Subject: Drury Centre Stage 2 (Fast Track)
Response to Section 67 RFI dated 5 September 2025

Ref: 25001

This memorandum responds to the key transport issues raised in the Section 67 Request for Information (RFI) from the EPA Panel dated 5 September 2025. Numbering follows the convention noted within the RFI.

Figure 1: Difference in PM Flows when SH1DC is added (green=increase; blue=decrease)

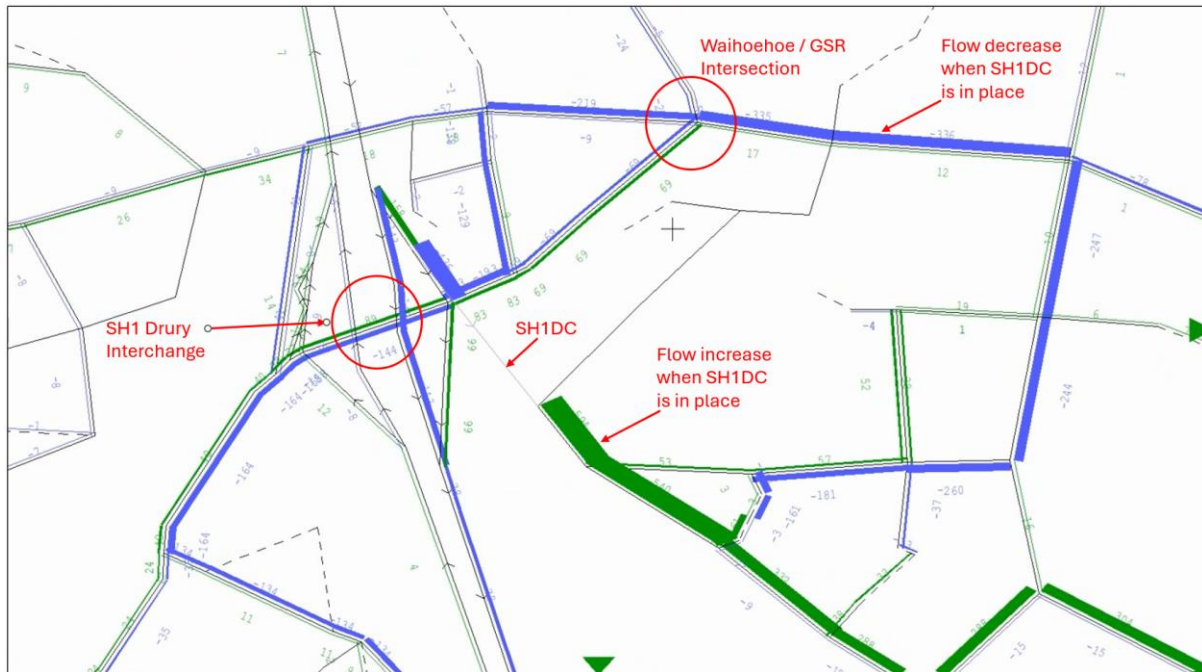
- c) Further to (b) above, should this road not be constructed (and the Norrie Road one-lane bridge be retained), can please assess / provide traffic volume diagrams as to where this traffic would be deviated to, given the one-lane bridge constraint (e.g., would it be to Great South Road).*

That said, the traffic model's use of Norrie Road as a convenient route to / from Drury East is not representative of the existing convoluted configuration – and the presence of the single-lane bridge – along its length. Accordingly, to assess the effect of downgrading the attraction of that route, further sensitivity testing was undertaken in Sidra. The testing was done for the PM peak hour only, as that is the most critical peak hour for the GSR / Waihoehoe Road intersection. In the interests of simplicity, we have carried out a single, extremely conservative sensitivity test which prevents any additional trips between the With and Without SH1DC scenarios from using the Firth Street / Norrie Road diversion.

The Saturn PM flow difference diagram (showing the difference in traffic flows in the PM peak with and without the SH1DC – already presented on page 12 of the Transport Response dated 16 August 2025) is shown below as **Figure 1**:

The image shows that without SH1DC in place, approx. 130 vehicles use Firth Street to access Norrie Road, which then proceed through the intersection to reach Waihoehoe Road and Drury East. The Sidra Vehicle Movement Performance (VMP) for the 3,800vph trigger threshold without any adjustments is shown in **Figure 2** below as a base for the analysis (this VMP output was previously presented on page 14 of the Transport Response dated 26 August 2021). The Norrie Road and Great South Road south arrival movements to are circled in red for ease of reference, and the average queue length on Waihoehoe Road (which constitutes a pass condition) is circled in green.

Figure 10: Added Pedestrian Refuge with Amended Bus Tracking Curves

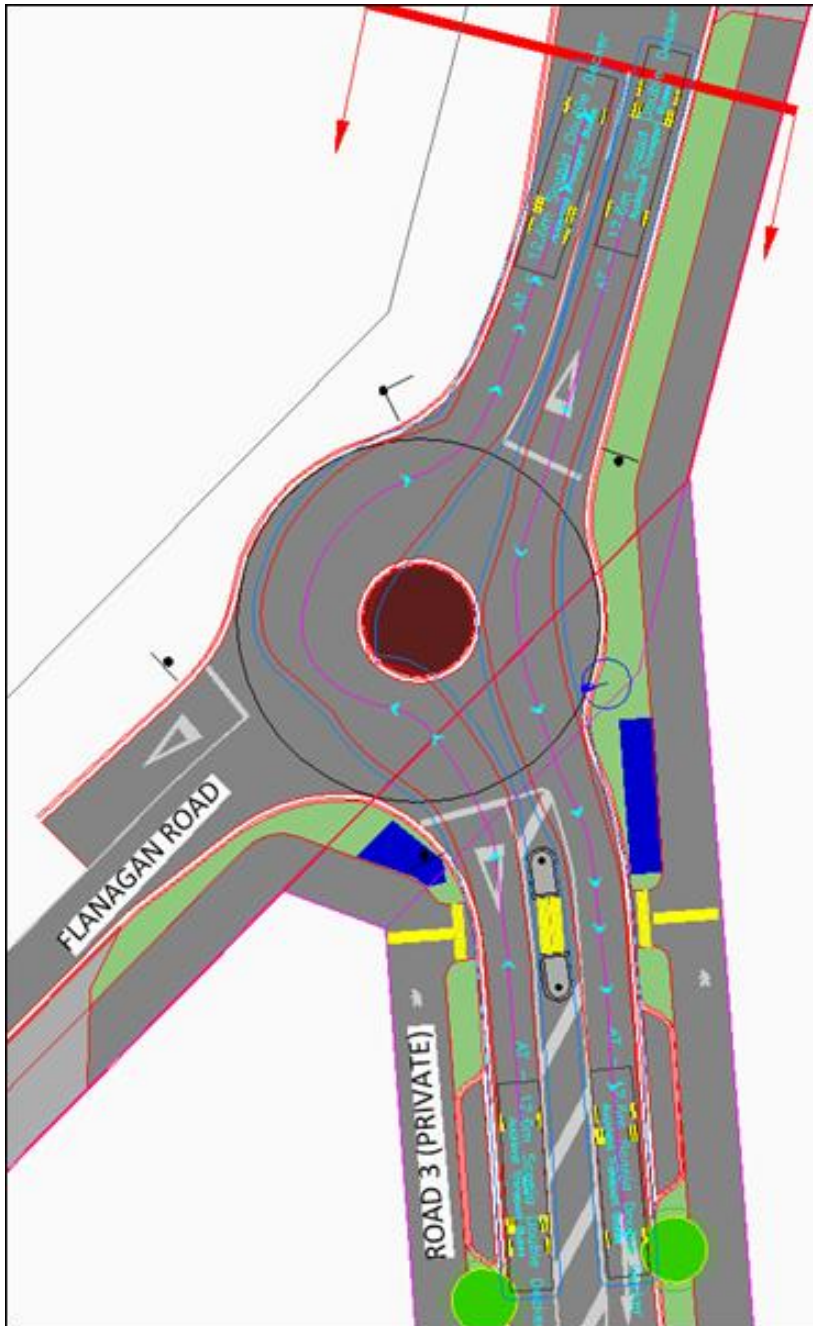
- g) Please provide a review of the Flanagan Road / Road 3 Proposed Roundabout in relation to pedestrian provision. In particular, please comment in respect of the southern leg (Road 3) and if changes are required, do they change the bus tracking?

The pedestrian desire lines and crossing locations have been reviewed. There is a pedestrian crossing location proposed on the southern leg of the roundabout that provides connection to Lot F. There is also a signalised intersection some 40m to the south of the Flanagan Road roundabout that also provides pedestrian connections to the western side of Road 3. Pedestrian crossings on the northern leg of the roundabout and western leg are not considered necessary as this land to the northwest of Flanagan Road is yet to be developed.

To enhance pedestrian safety, a pedestrian refuge island has been added to the flush median between the crossing point showing tactile paving, and bus tracking has been rerun. The updated drawing is provided in **Figure 10** below.
